REQUEST FOR STATEMENTS OF QUALIFICATIONS No. 22-001

**Greater Nanaimo Pollution Control Center MCC Replacement Project
Engineering Services**

Addendum 2

Issued: January 12, 2022

PROJECT START DATE (M/Y)	APR/2015
PROJECT NO.	60343972
FILENAME	E-252.dwg
RDN DRAWING No.	GN-E-321
DRAWING No.	E-252

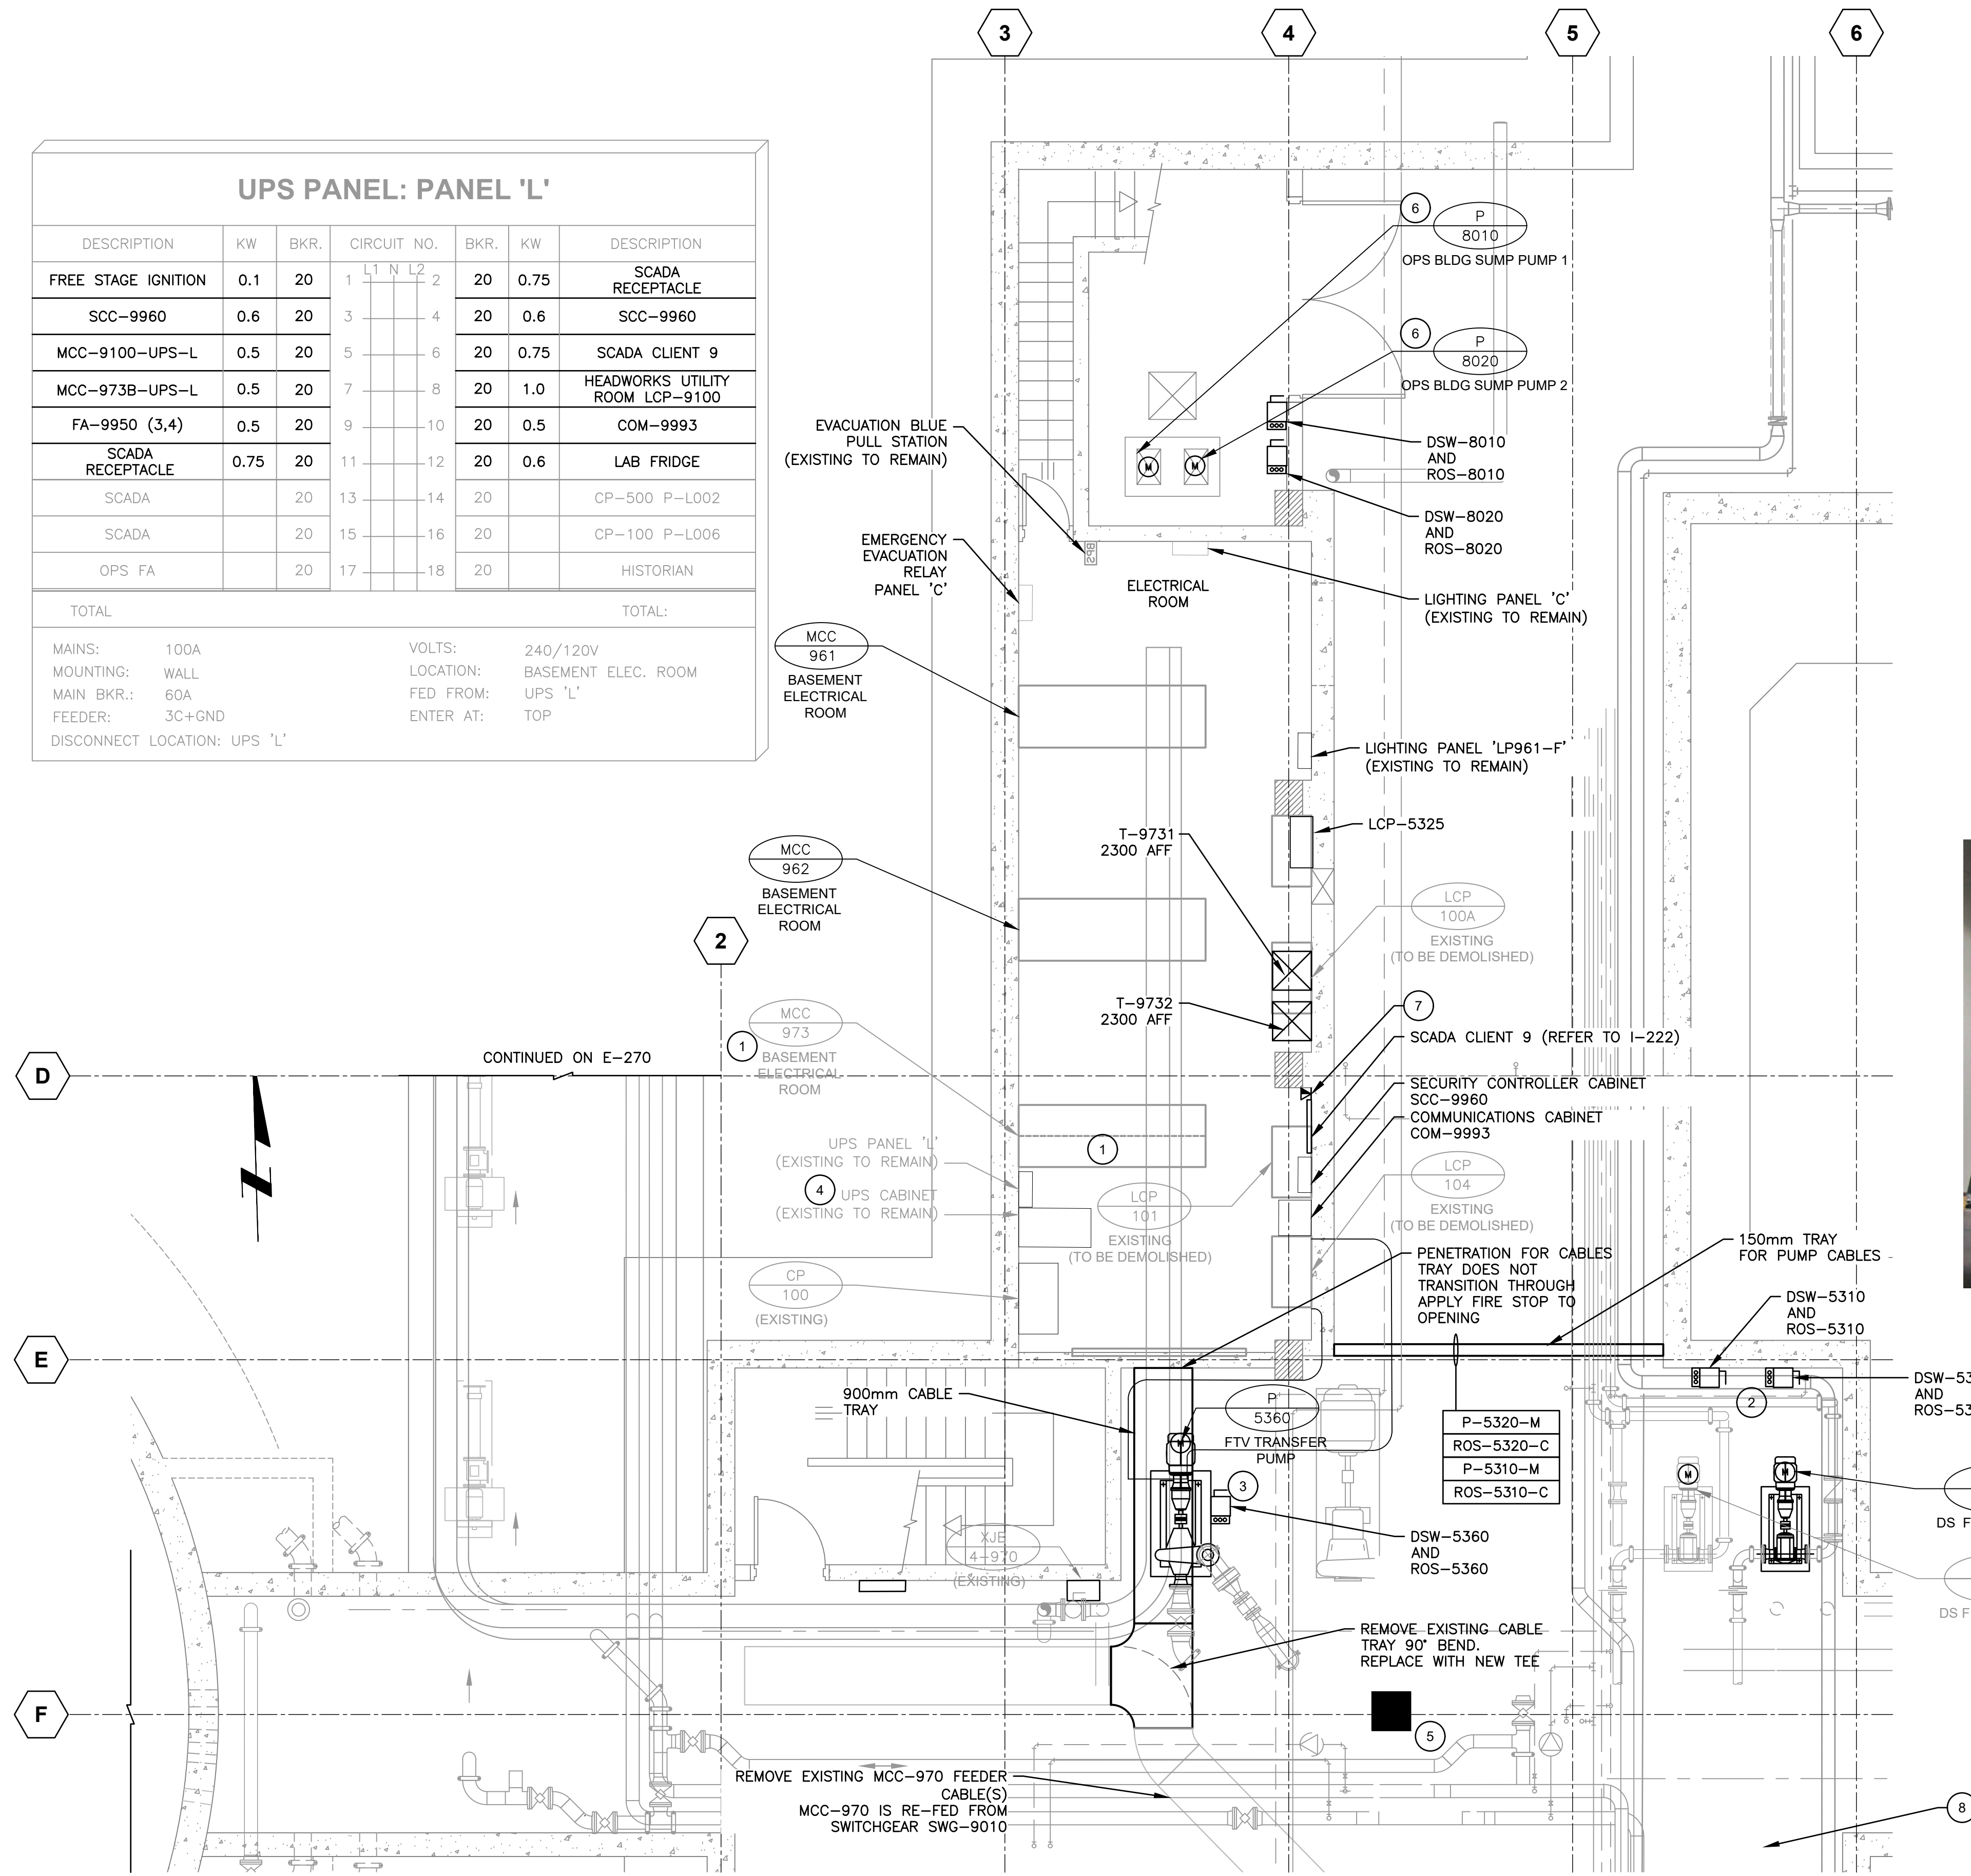
9	Can the RDN provide the Electrical Room Layout drawing for the Basement MCC Room?	GN-E-321 Operations Building Basement Level Plan drawing is available and attached to this addendum.
10	Confirm if any new or upgraded loads are being added to the MCCs listed in the RFSQ.	Some existing loads are decommissioned and will be marked as spare. There will not be additional equipment added.
11	Is there a sample document for the Process Control Narrative, just want to understand if this is regarding our QA/QC processes or the design process (conceptual/design brief, schematic, detailed design, construction & CA etc.).	Process Control Narratives (PCN's) are a written description of how a control system is expected to operate. These documents are used by programmers and engineers to aid in the implementation of control system logic and clearly define system parameters (alarms, setpoints, automatic/manual modes, interlocks, etc.). The RDN is developing a standard template that will be used by the proponent during the engineering phase.
